PLAT COMMITTEE

Case Number:	2026-PLT-028
Property Address:	7305 Kentucky Avenue (<i>Approximate Addresses</i>)
Location:	Decatur Township, Council District #21
Petitioner:	Oberlin Development LLC, by Brittany Edwards
Zoning:	C-S
Request:	Approval of a Subdivision Plat to be known as Replat of Lots 50 Through 53 and Common Areas "A" and "B" Of Oberlin At Camby Village Section 1B And Of Lots 54 Through 67, Lots 80 Through 91, and Common Areas "E" and "F" Of Oberlin At Camby Village Section 2, subdividing 11.11 acres into 27 lots, four common areas, and one block.
Waiver Requested:	None
Current Land Use:	Undeveloped
Staff Reviewer:	Michael Weigel, Principal Planner I

2026PLT028 ; Proposed Plat

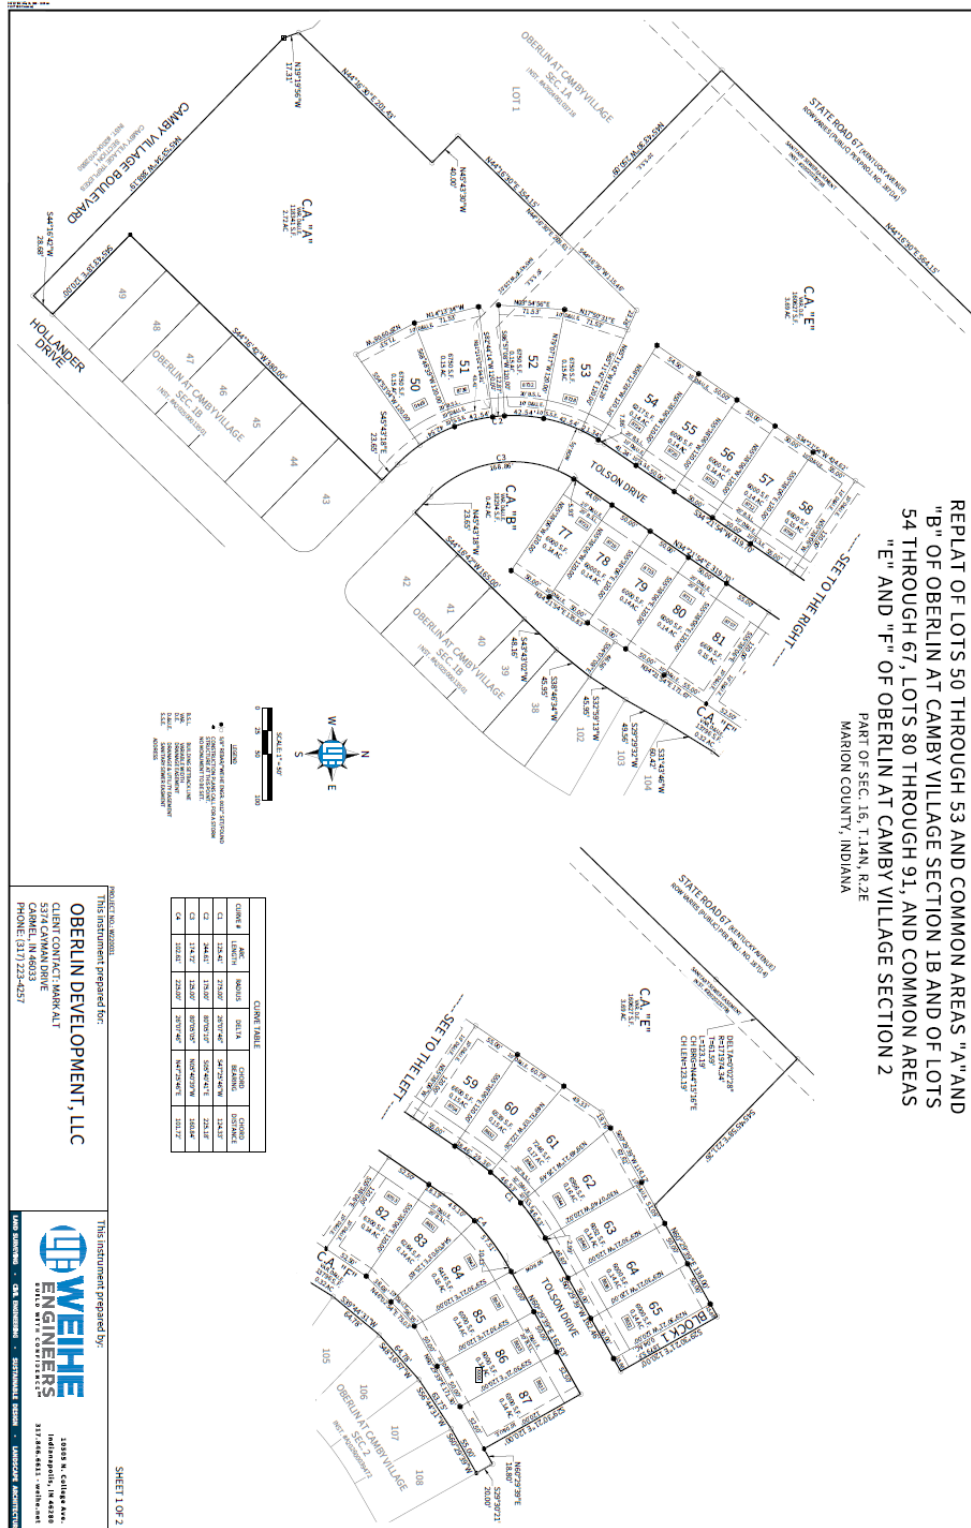
Staff recommends that the Plat Committee **approve** and find that the plat, file-dated June 1, 2026, complies with the standards of the Subdivision regulations, subject to the following conditions:

1. Subject to the Standards and Specifications of Citizens Energy Group, Sanitation Section.
2. Subject to the Standards and Specifications of the Department of Public Works, Drainage Section.

3. Subject to the Standards and Specifications of the Department of Public Works, Transportation Section.
4. That addresses and street names, as approved by the Department of Metropolitan Development, be affixed to the final plat prior to recording.
